Author's Response

to Reviewer Feedback on the Preprint

"Improved method for temporally interpolating radiosonde profiles"

Linus von Klitzing (linus.vonklitzing@uni-hohenheim.de)¹,
David D. Turner², Diego Lange¹, and Volker Wulfmeyer¹

Figure 1: An example comparison between the interpolated profiles with (green) and without HN (grey) and the reference profile (black) of potential temperature on April 25, 2019, 20:30 UTC. This figure is not shown in the manuscript.

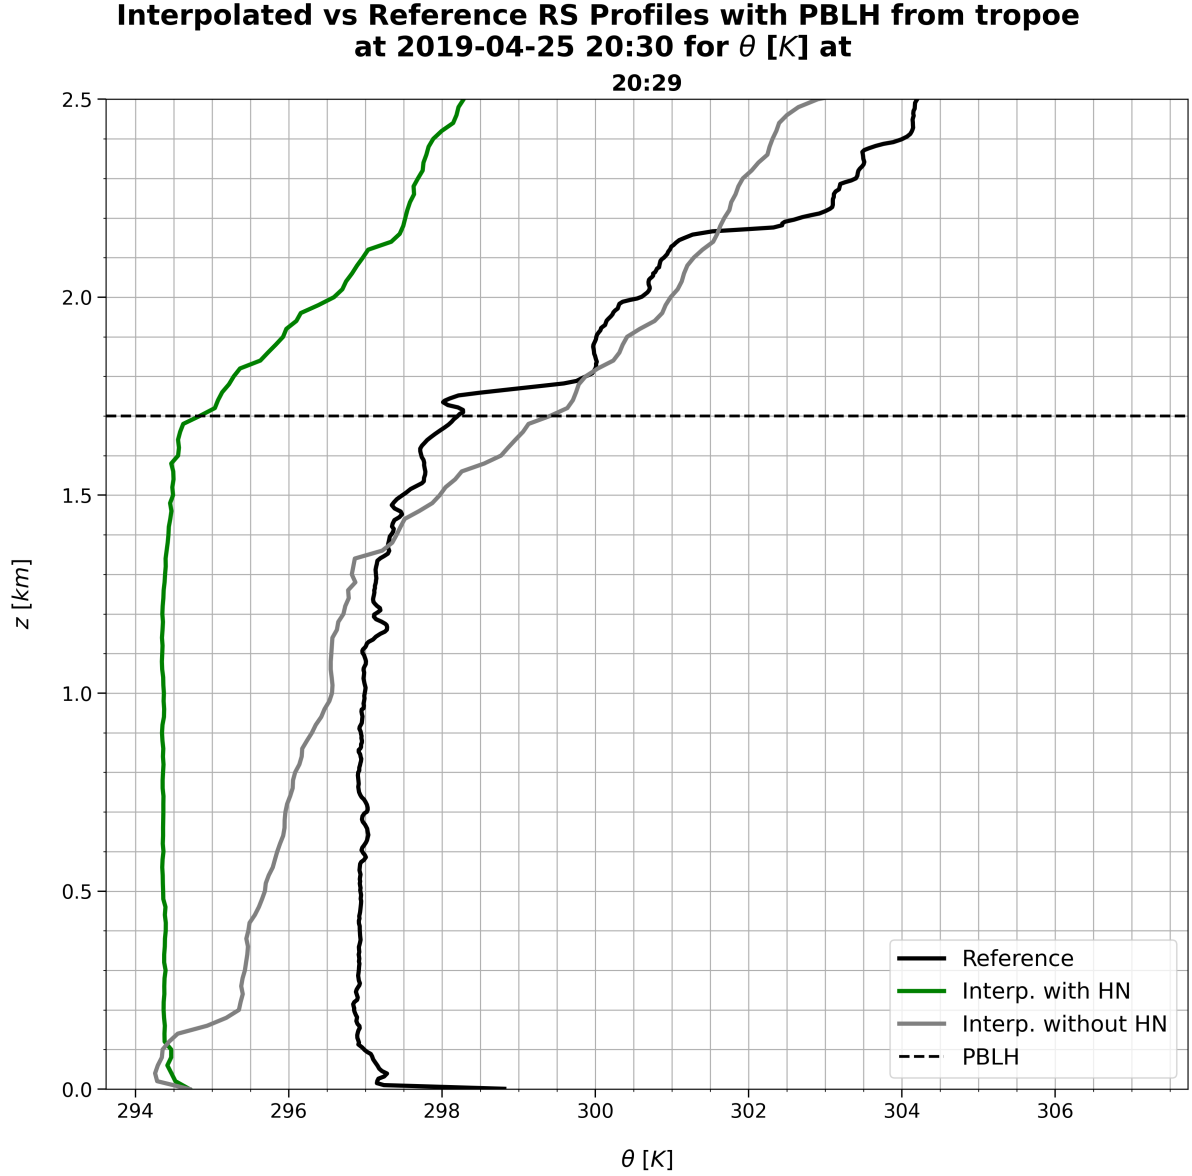
Comment: Lines 43-45: The estimate of the PBLH will have some dependence on the instrument used. Have you considered the impact of these different definitions/measurements of the PBLH? E.g., I am wondering if the increase in standard deviation of the water vapor mixing ratio in figure 3d near the top of the boundary layer is mostly due to varying definitions of the PBL depth? I also wonder, if the technique **REQUIRES** this separate measurement of PBLH, would there still be value in using the interpolated PBLH depth (as determined from the radiosonde profiles) to normalize the height? I would hypothesize that this would still provide an improvement over the standard grid interpolation.

The increasing standard deviation at the top of the boundary layer of the bias for potential temperature and humidity was not explained by us in the manuscript, especially regarding the new interpolation technique, which is why we wanted to add this explanation now. Examining the individual interpolated and reference profiles reveals a significant spread in the realized shapes of the gradient at the top of the boundary layer (see our more detailed description below). The reason should not be, however, a varying definition of the PBLH,

as we consistently defined this as the height of the maximum gradient, although, admittedly, the automatic detection of this height might not be correct in every single profile. A good example of this for potential temperature is shown in Figure 1 (not included in the manuscript). You can clearly see that the HN interpolation and the reference sounding have a comparable PBLH, but the shapes of the corresponding gradients differ, leading to a more variable bias at these heights compared to the rather constant potential temperature values in the mixed layer. Just as a side remark, here you can also see a good example of how much worse the structural representation of the reference profile by the non-HN interpolation is.

Figure 2: Improved version of Figure 2 from the Preprint. This updated version covers only a zoomed-in area and includes the planes that represent those 85% of data that are closest to the ideal values of $r = 1$ and $\log_2(\sigma_{\text{interp}}/\sigma_{\text{ref}}) = 0$.

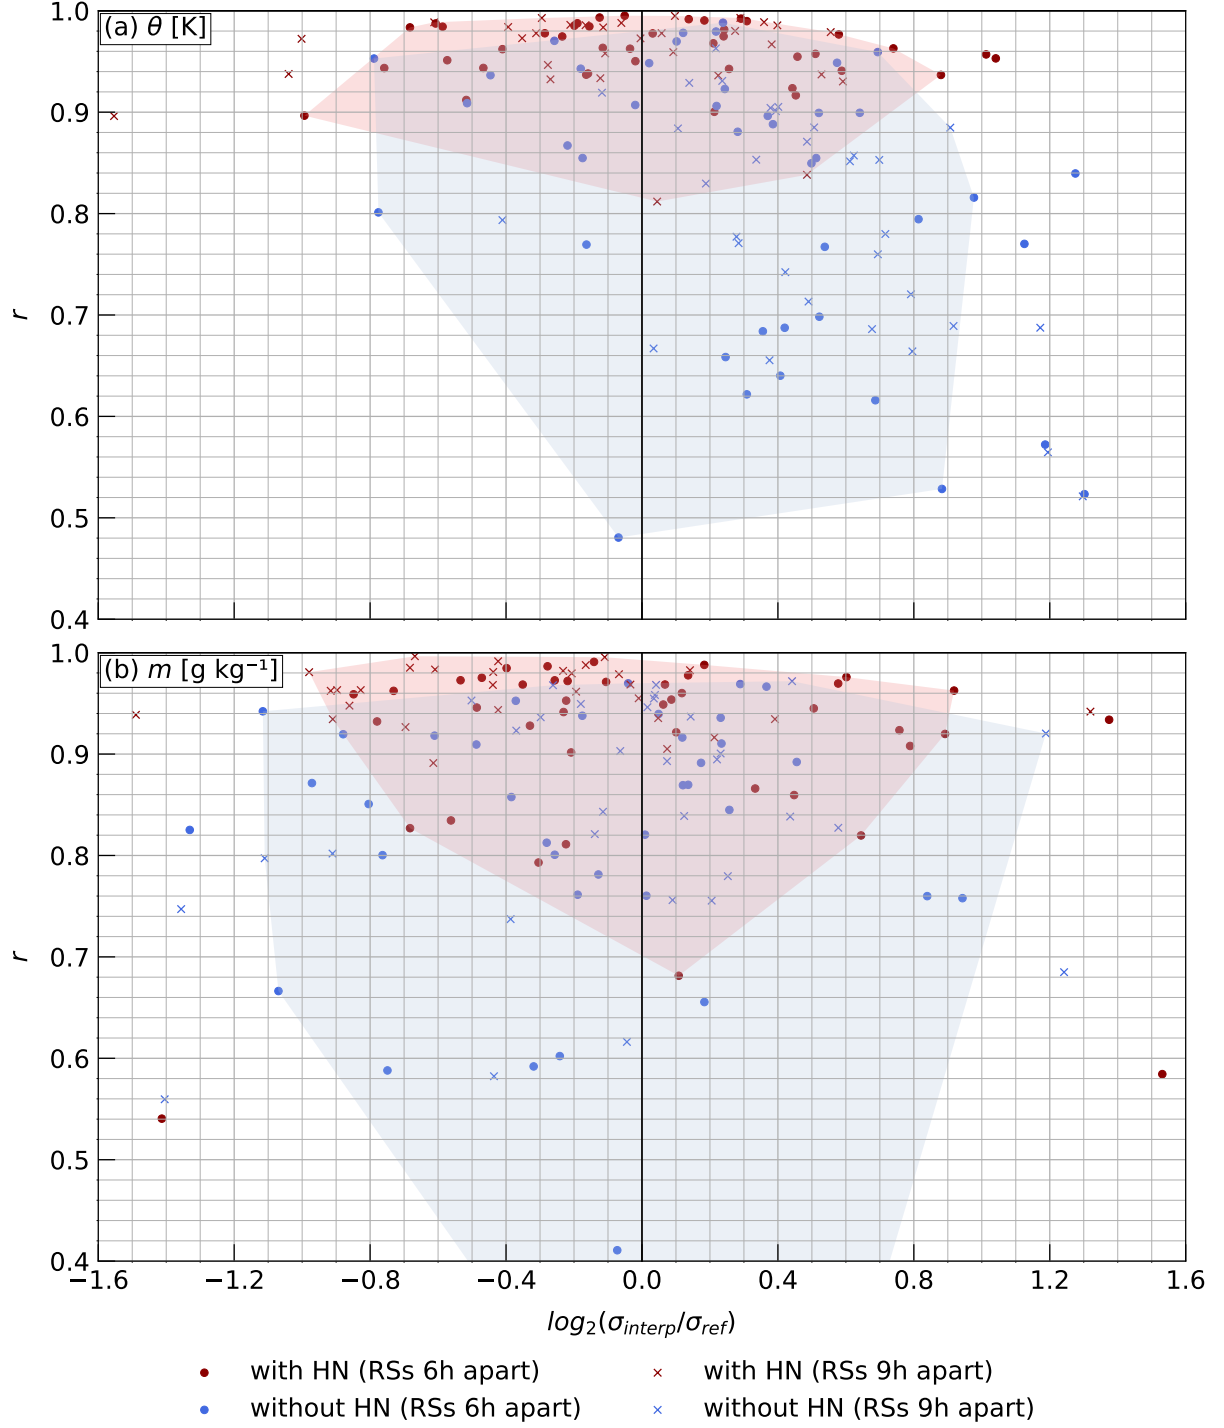
Comment: I find Figure 2 very difficult to read and interpret as a scatter plot. Both discerning the different markers used to represent the different interpolation scheme and radiosonde separation, but also the fact that most of the

points are clustered in one are with lots of white space among the plot. Have you considered some type of contouring or 2D histogram (or something else) to make this easier to read and interpret? I do find the table communicates the differences much more clearly.

Comment: Figure 2: For the discussion regarding Figure 2 you are using cases and profiles interchangeably. I interpret a "case" as being a convective boundary layer event and a profile as representing a 10 min interpolated vertical profile corresponding to the 10 min average Raman lidar profile (based on earlier discussion related to Fig. 1). Please clarify what the 79 profiles represent, how many profiles are compared per event (would it be 2?) and state how many profiles are represented in Fig. 2a and 2b for the HN and non-HN profiles.

The scatter plot in Figure 2 as presented is hard to interpret, though Table 1 provides quantitative values to support the analysis. A joint PDF might be easier to visualize the differences, though there may not be enough points.

Reply: *This is a fair point and we agree that the presentation of our results would benefit from a clearer visual presentation. We therefore modified Figure 2 in two ways. First, we zoomed into the center area of the figure to reduce the wasted space at the borders (the r -axis begins now at 0.4 instead of 0 and the axis representing $\log_2(\sigma_{\text{interp}}/\sigma_{\text{ref}})$ covers now the interval between -1.6 and 1.6 instead of -3.2 to 3.2). This leads to a few more data points that are not shown; however, the overall message of this plot is not compromised by this in our view. Second, we added the shadows of the planes (for HN and non-HN respectively) to the plot that are span by those 85% of the corresponding data points that are closest to the ideal values of $r = 1$ and $\log_2(\sigma_{\text{interp}}/\sigma_{\text{ref}}) = 0$. This immediately demonstrates that the HN interpolation technique produces more data points closer to the ideal values.*

Action: We updated Figure 2 with the changes described above, as demonstrated also in Figure 2 of this response. Additionally, we updated the figure caption from "~~For better visualization, seven data points (five without and two with an HN) between $r = 0$ and $r = -1$ are not shown in (b).~~" to "For better visualization, twelve data points (seven with and five without an HN) are not shown in (a), as well as 16 data points (six with and ten without an HN) in (b). This results in 72 and 74 data points shown in (a) for HN and non-HN interpolations, respectively. In (b), 73 and 69 data points are shown, respectively. The shown planes are spanned by those 85% of data points that are closest to the ideal values of $r = 1$ and $\log_2(\sigma_{\text{interp}}/\sigma_{\text{ref}}) = 0$." and added a description for the added planes (lines 247-249 of the revised manuscript): "The shown planes (semi-transparent) visualize how close most of the data points for the HN and non-HN interpolation are to the ideal values of $r = 1$ and $\log_2(\sigma_{\text{interp}}/\sigma_{\text{ref}}) = 0$ respectively by being spanned by those 85% that are closest." Additionally, we strengthened our discussion of this updated figure by adding (lines 255-257 of the revised manuscript) "This is visualized especially well by the shown planes. The plane that is spanned by those 85% of data that is closest to the ideal values is obviously smaller for the HN interpolation than for the non-HN one, representing a smaller spread to less ideal values."

Finally, regarding the readability and interpretability of Figure 2, we agree that the previous presentation was convoluted in some parts and wasted space in others. As already stated in our reply to the comparable critique of the first review, we improved Figure 2 by zooming more into the relevant part and adding shadows of the planes that are span by those 85% of cases/data points that are closest to the ideal values of $r = 1$ and $\log_2(\sigma_{interp}/\sigma_{ref}) = 0$. For more details, please refer to the reply above.

The caption of Figure 2 now includes "This results in 72 and 74 data points shown in (a) for HN and non-HN interpolations, respectively. In (b), 73 and 69 data points are shown, respectively."

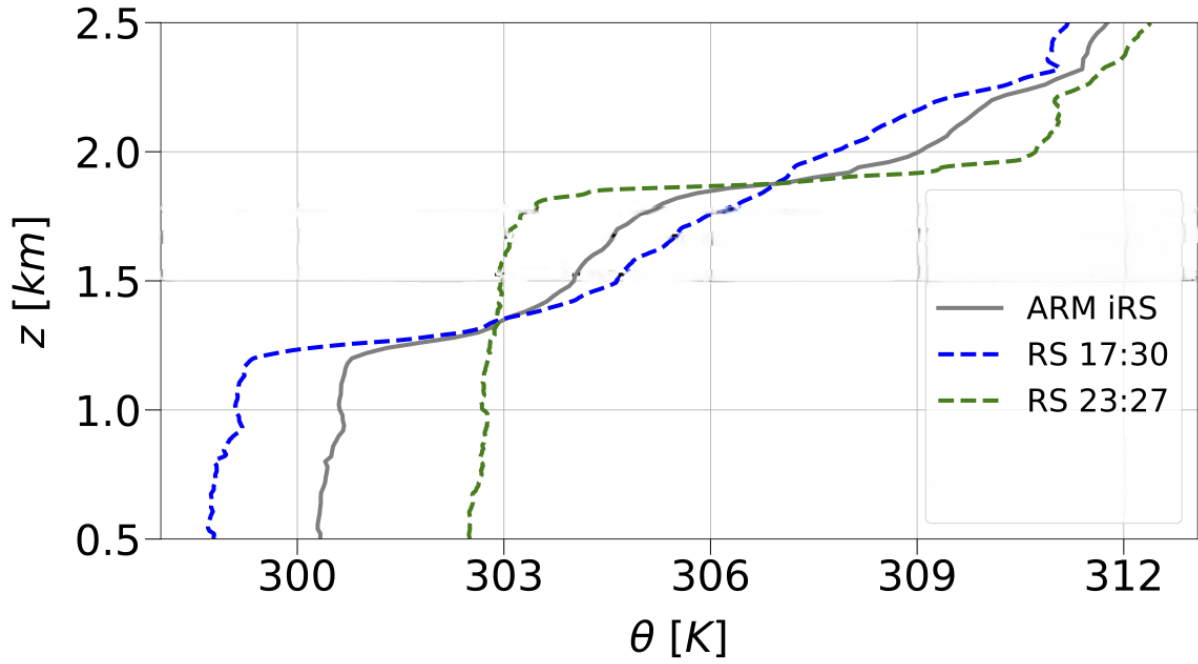
Comment: Line 215: What is meant by "introduction of nonphysical atmospheric layers as artifacts of insufficient interpolation?" This is unclear to me.

Reply: *Fair point. We hope to make this clearer by giving a concrete example. The averaging of non-HN profiles may lead to the situation where, at a certain height, the warmer (in terms of potential temperature) free atmosphere of the earlier profile (the CBL is not that far developed earlier in the day) is averaged with the cooler mixed layer of the later profile (as the CBL developed during the past time and now has a mixed layer at the height of interest). The average profile will be warmer than the earlier and cooler than the latter input sounding at this height, so it will appear as if there is an additional layer (when examining this interpolated profile solely). However, this is a non-physical artifact resulting from the insufficient interpolation. We present a visualization of this in Figure 3 (not shown in the manuscript).*

Action: To make our analysis clearer, we incorporated a brief additional description (lines 262-265 of the revised manuscript): "For example, averaging an early-day potential temperature sounding with a lower PBLH together with a later-day sounding that has a higher PBLH (using the non-HN technique) will produce an apparent extra 'layer' at heights where the warmer free atmosphere from the first sounding is averaged with the cooler mixed layer from the second."
